City of Mississauga

City Department and Agency Comments

Date Finalized: 2021-05-05 File(s): A185.21

Property Address: 3485 Semenyk Court

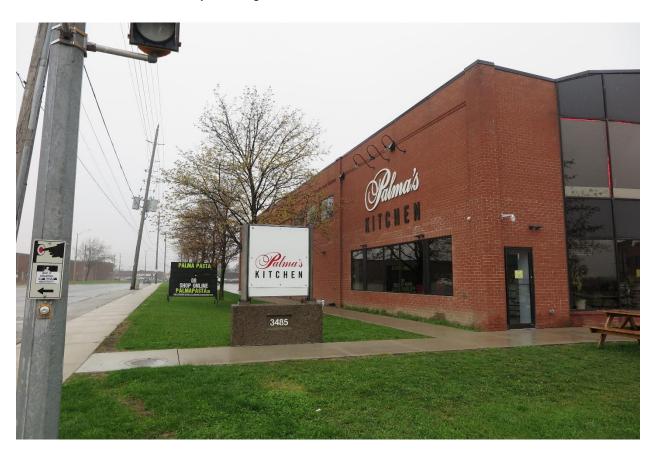
This department has no objections to the proposed location of the patio. The patio is being proposed in a location which does not impact on the abutting municipal sidewalk or the existing sight triangle at the intersection of Semenyk Court and Central Parkway West. With regards to drainage, we note that there is an existing catch basin in close proximity to the proposed patio which would accomodate any drainage in the area.
